Office Action Summary	Application No. 10/649,997	Applicant(s) MORI ET AL.	
	Examiner HUNG T. NGUYEN	Art Unit 2841

Claims 1, 2, 6-7, 9-14 are rejected under 35 U.S.C. 103(a) as being unpatentable over Chang (US 6050849) in view of Milan (US 6716047).

Sheet 12 of 15

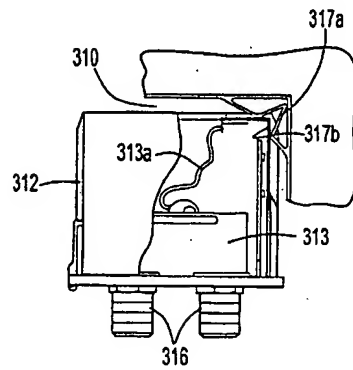
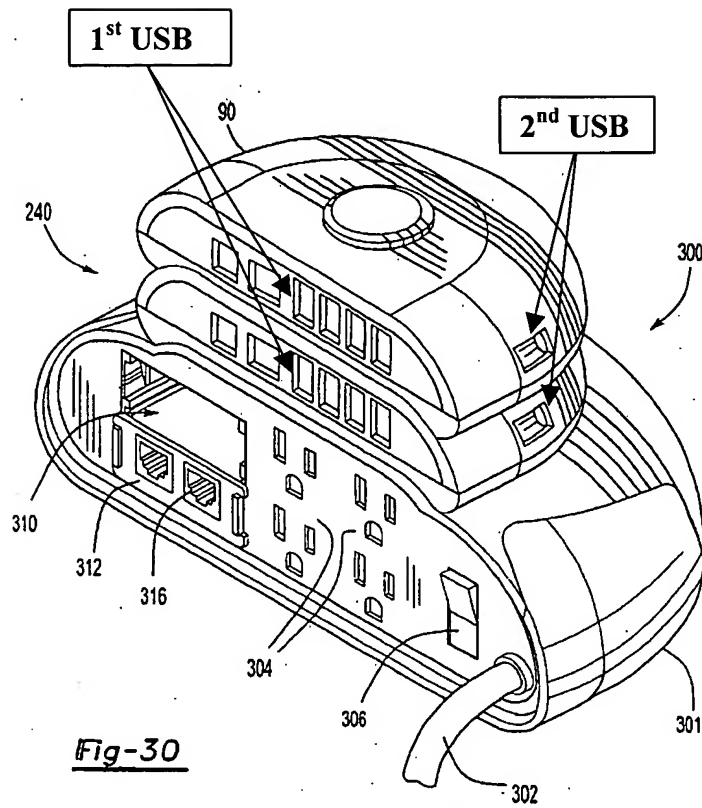
Regard claim 1: applicant argues that a first USB port at a first surface and a second USB port at a different surface of a USB hub". This argument is not found to be persuasive because Milan teaches first USB port (element 138, figures 18-20) at a first surface and the second USB port at a different surface of a USB hub (element 24). In addition, Milan also teaches the second USB port at a different surface of a USB hub as show in figure pasted below.
